RECALL

Model	Vehicle Identification Number Range
VN2000-A1/L	JKBVNMA1/4A000059 thru 004668

Subject

VULCAN® 2000 FRONT BRAKE HOSE DAMAGE WARNING AND RECALL NOTICE

Inspection of the Brake Hose:

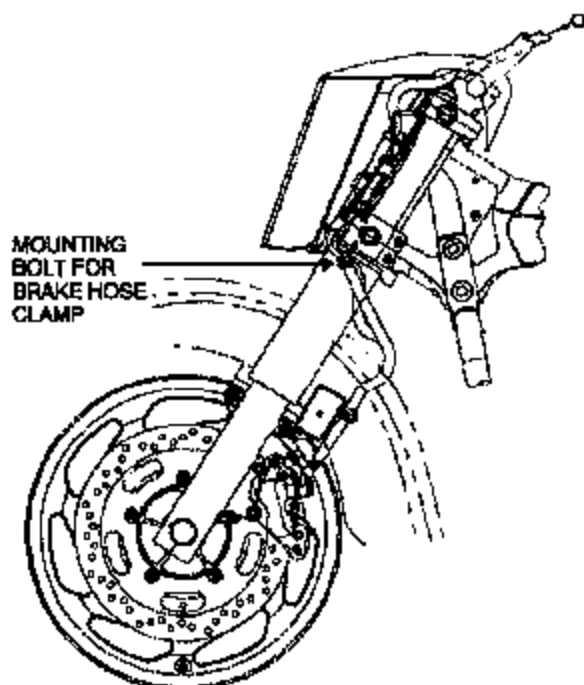
- Check the brake hose routing, the hoses should arc down through the lower hose clamp, and down to the calliper.
- If the brake hose is trapped between the front fork and fender, dislodge it.
- Check the brake hose for abrasion damage.
- If the brake hose shows indications of abrasion damage from the front fork cover, replace the brake hose.

Installation of the Brake Hose Clamp:

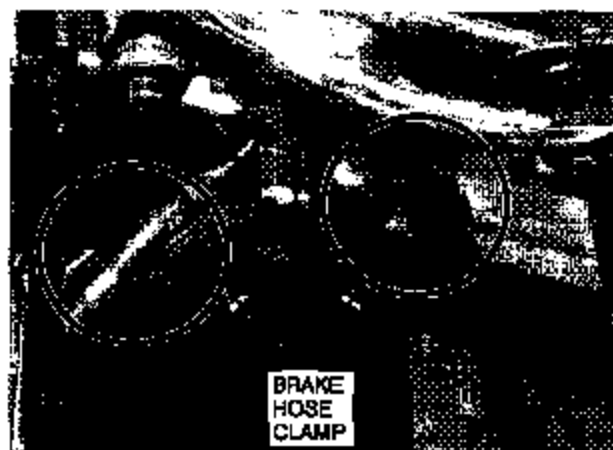
- Remove the brake hose mounting bolt under the lower triple clamp.

- Insert the brake hose into the clamp as shown.

- Discard the original bolt and tighten the hose clamp using the bolt supplied with the clamp kit.

Brake hose mounting bolt: 6.9 N-m (0.7 kgf-m, 61in-lb)
--
